The following changes to the tender documents are effective immediately and will form part of the contract documents:

Enquiries received during the Solicitation Period:

3.03 TOLERANCES

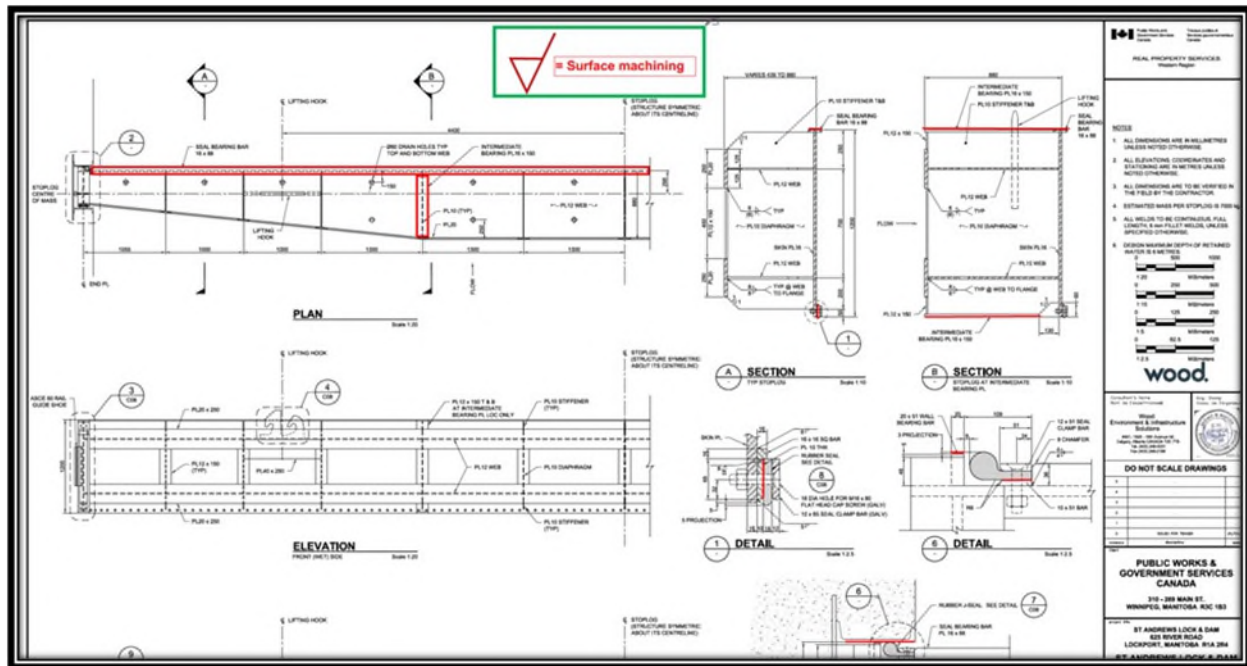
Question 2: In the Division 05 – Metals 3.03 mentions machining seal bearing bar, wall bar and bearing plate face but in the drawing C07, we don't see the machining symbol. Please have a look at the noted dwg and confirm if we have to include all red markup as machining surfaces (see pictures below).

Response: It is the Contractor's responsibility to develop a work plan to achieve the specified tolerances.

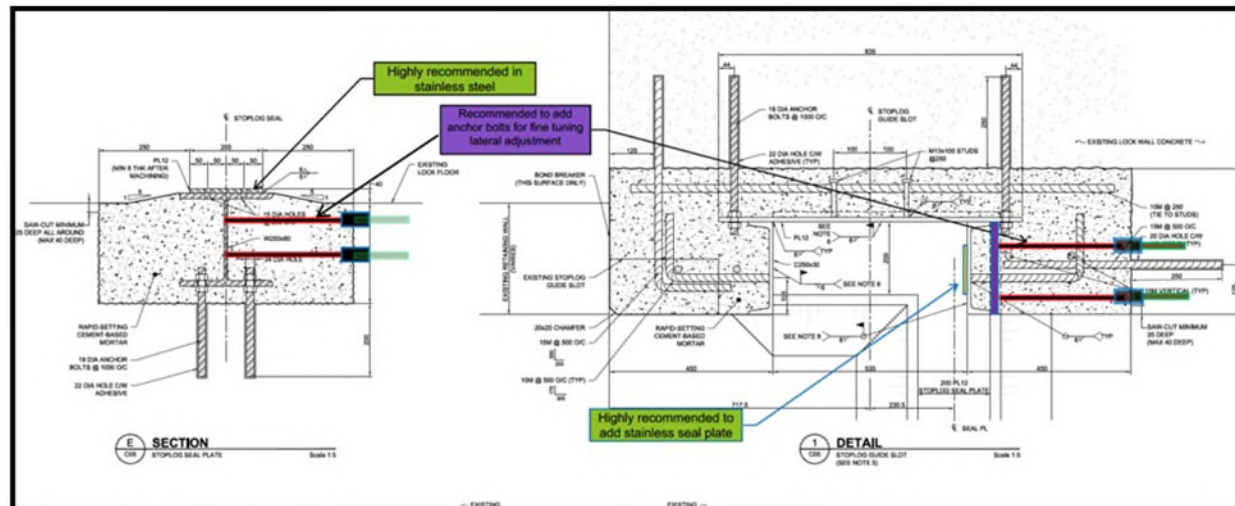
Question 3: Actual sealing path shown on detail #1 of dwg C06 doesn't have stainless plate to permit the J-seal to slide and doesn't have material provision for machining. This sealing path will also act as a rolling path (bearing surface) to transmit the load from the stoplog to gain (see attached dwg noted). Should we include a stainless steel plate provision for machining and sealing/rolling path? If the answer is positive, please indicate the plate dimension.

Response: No, do not include a stainless steel plate in the guide slot.
